ADDENDUM #2

Bid #25-JHP-021

New Ticket Booth at Aberdeen High School

This Addendum is issued in response to prospective bidder's inquiries and to add/clarify verbiage in the Bid.

DRAWING NO:
A1.7
FWA JOB NUMBER: 2241105.00

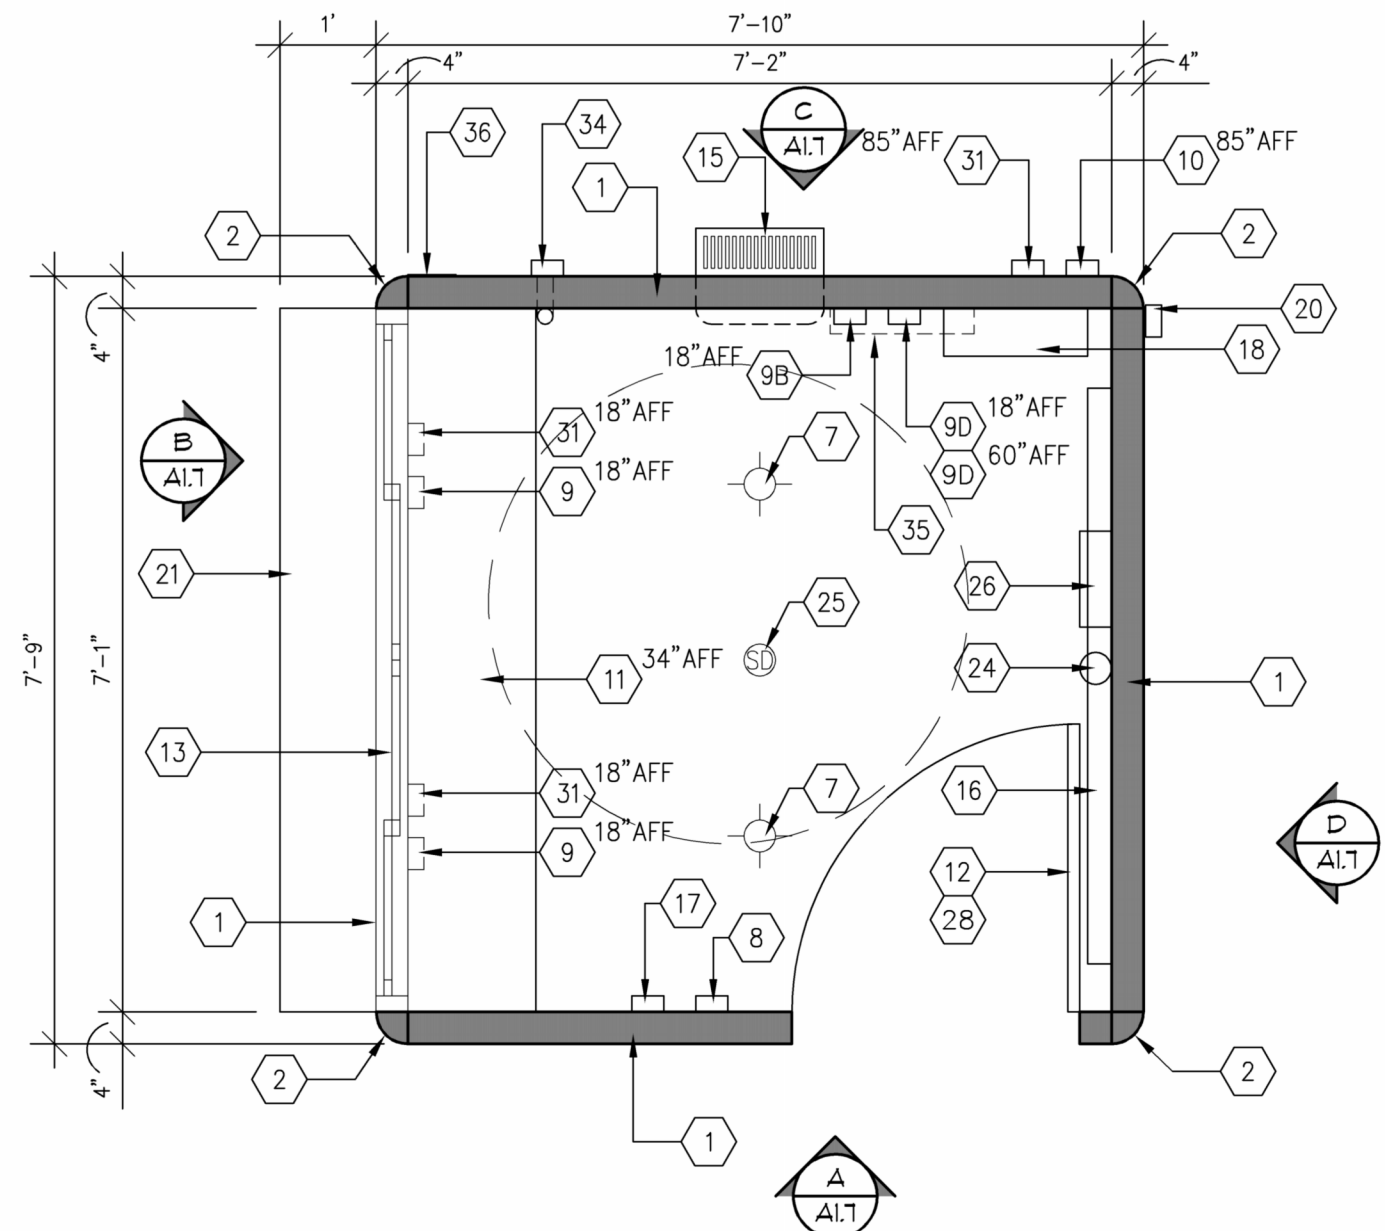
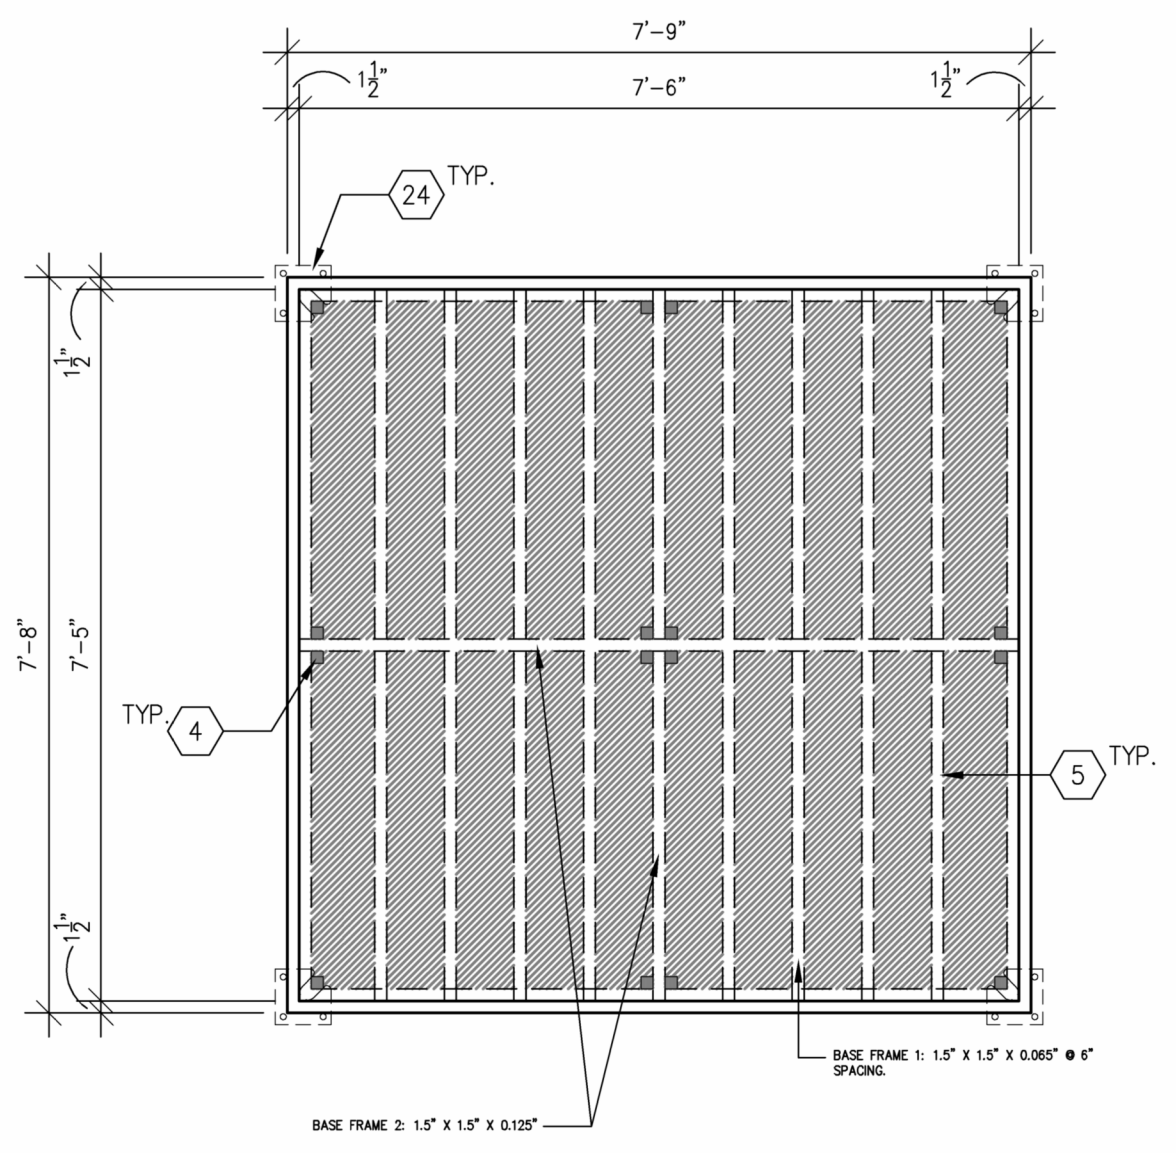
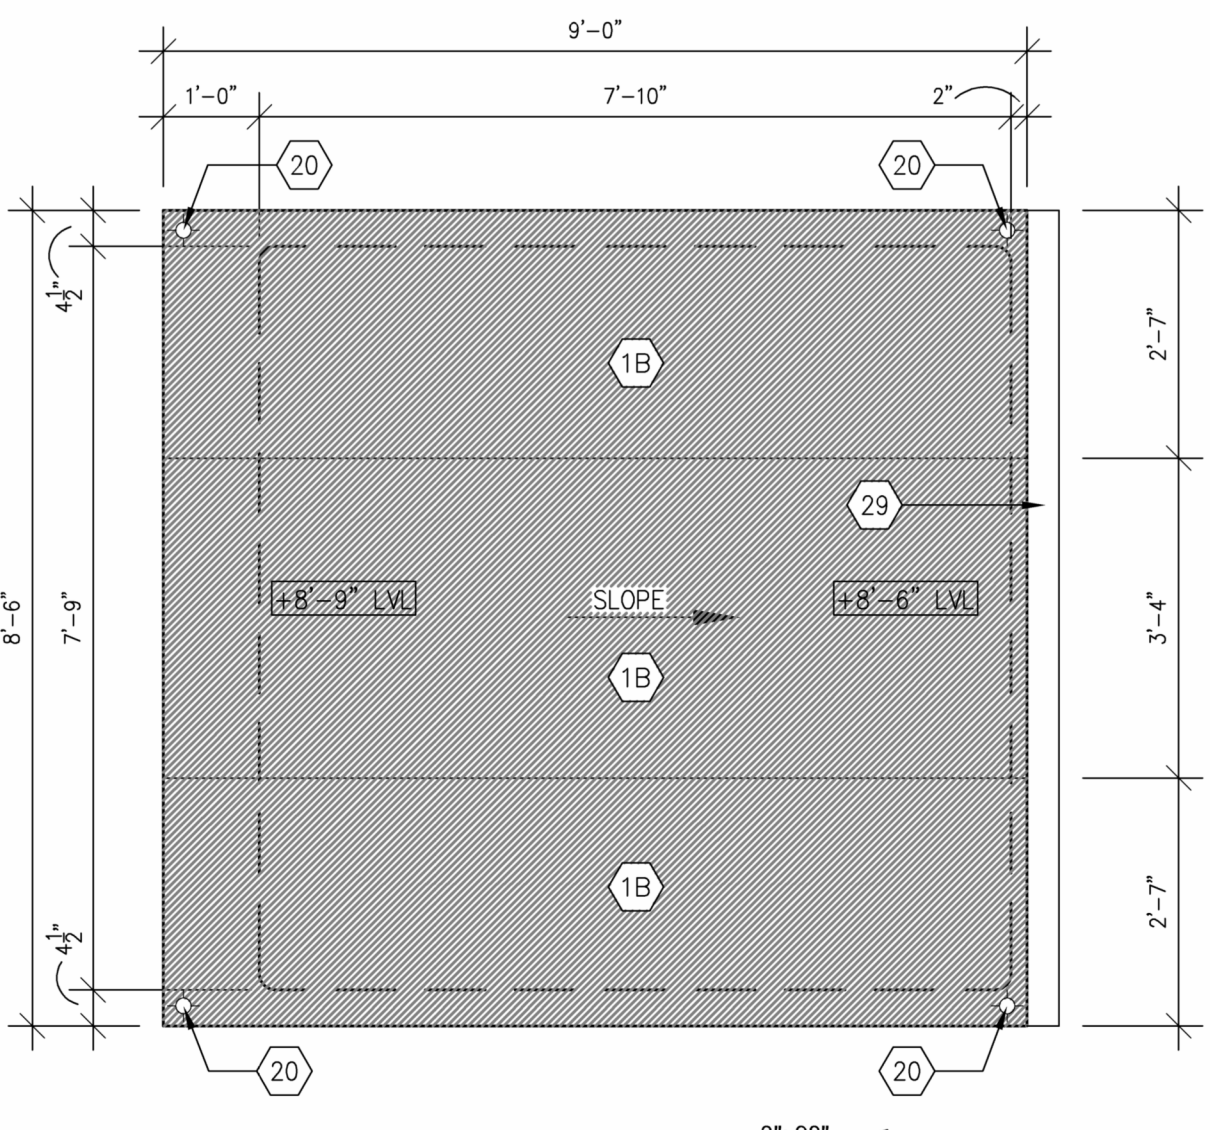
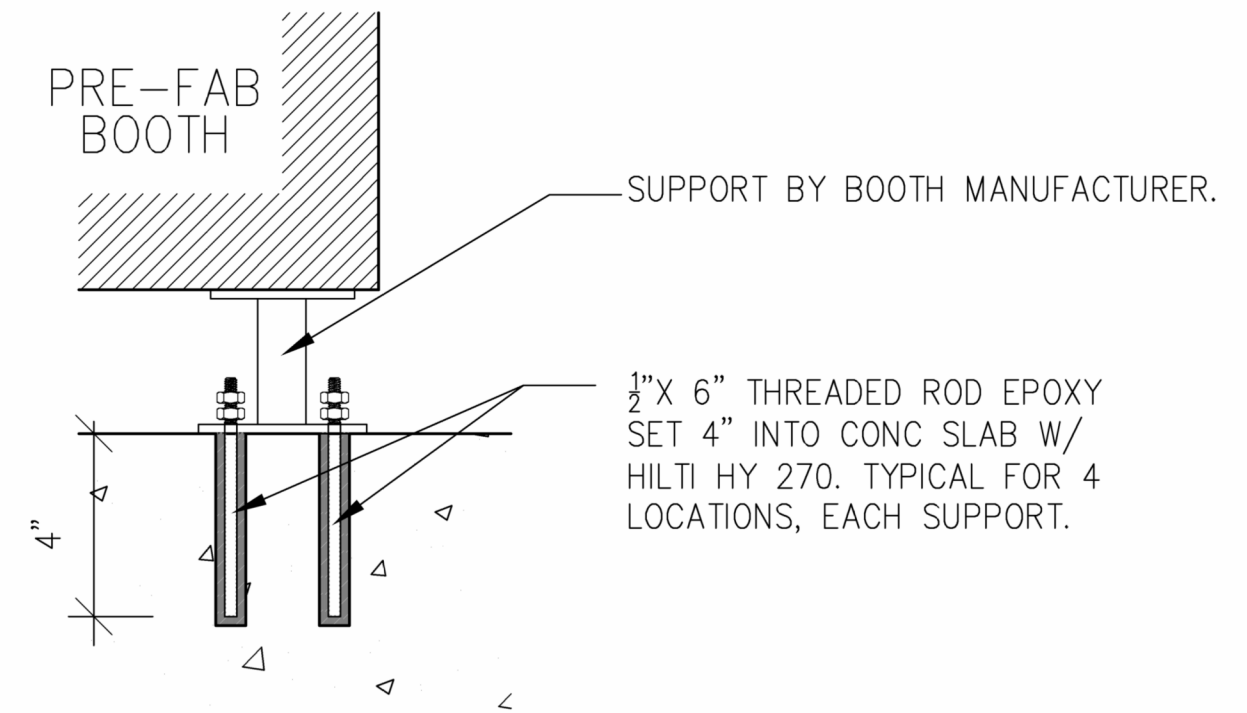
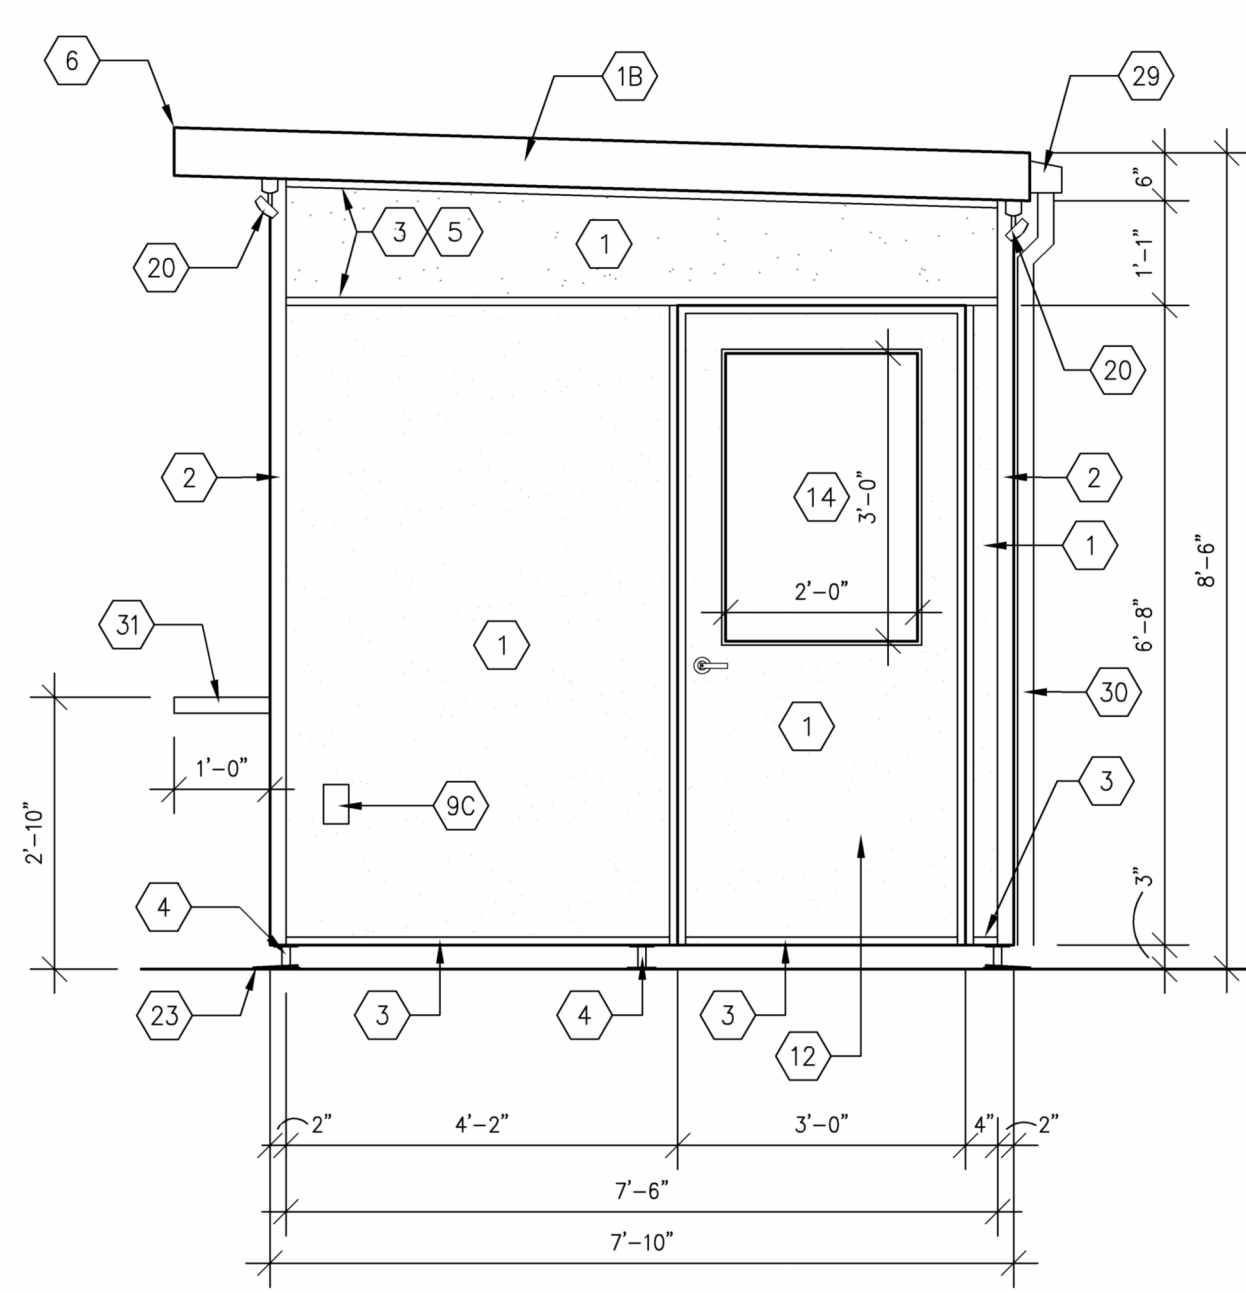
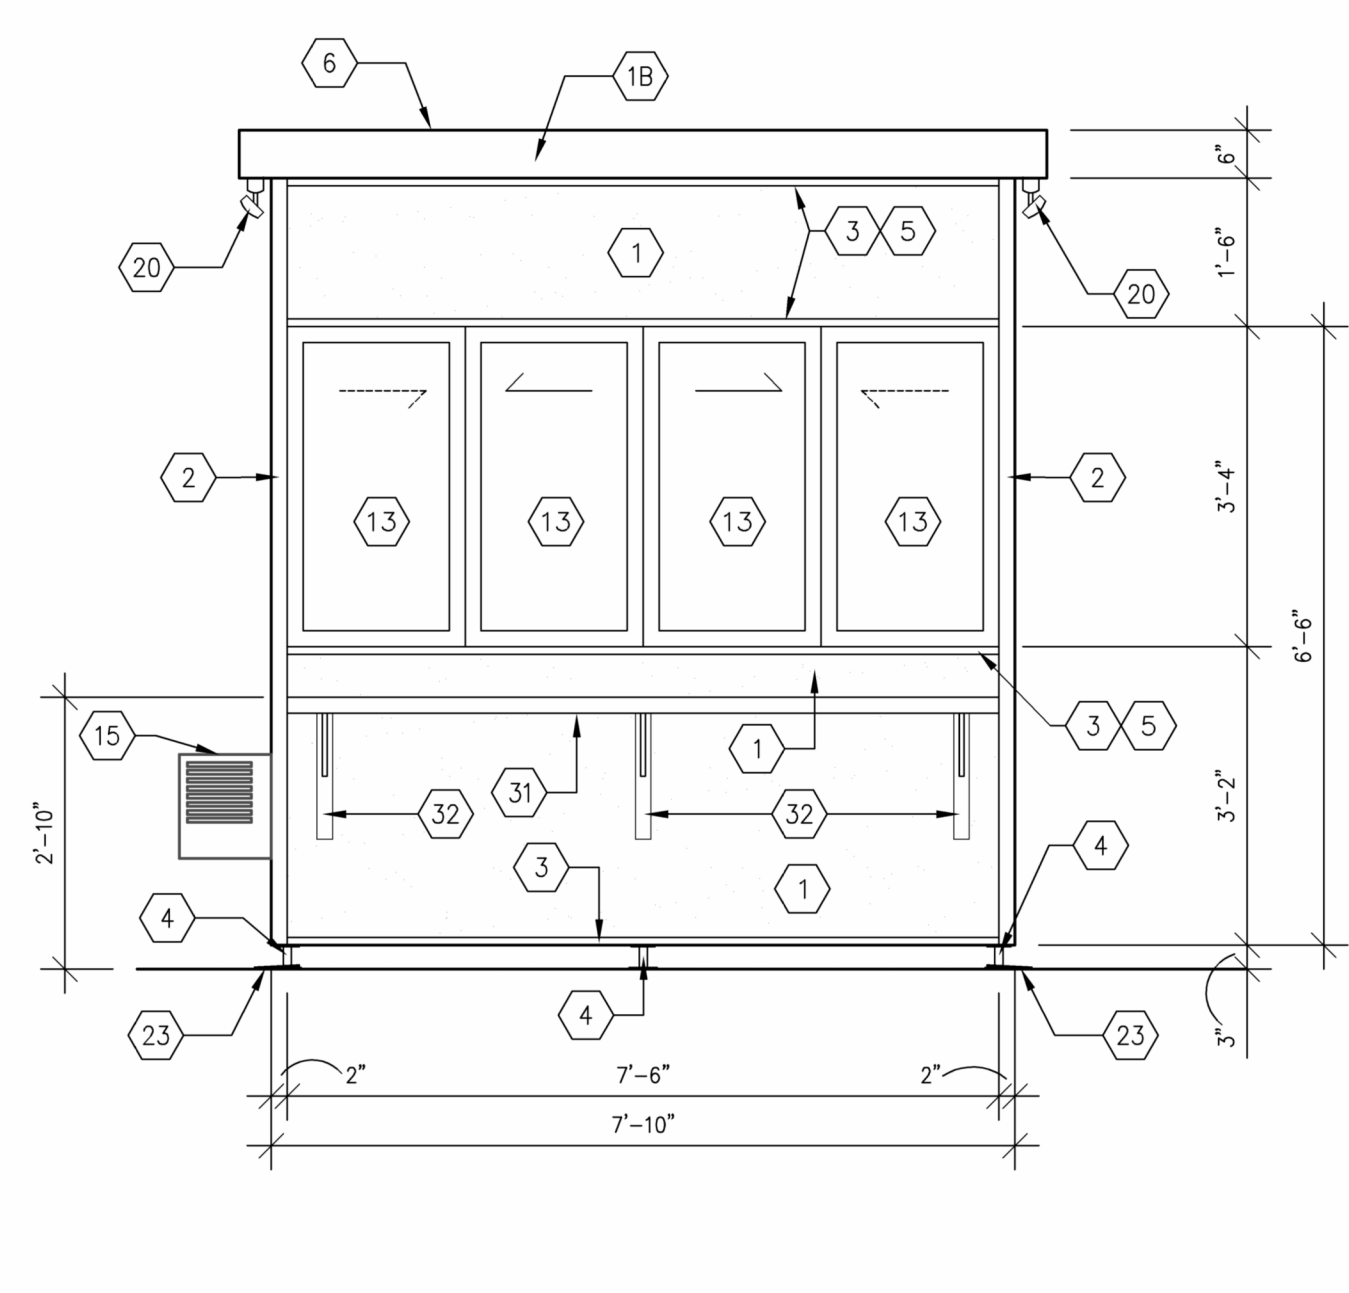
1. **REVISION:** Revised Drawing A1.7 – Revised in response to permit comments. Ticket booth upgrade to comply with IECC requirements.
2. **REVISION:** Revised Drawing A5.3 – Added in response to permit comments.
3. **QUESTION:** Please confirm no bid bond is required.
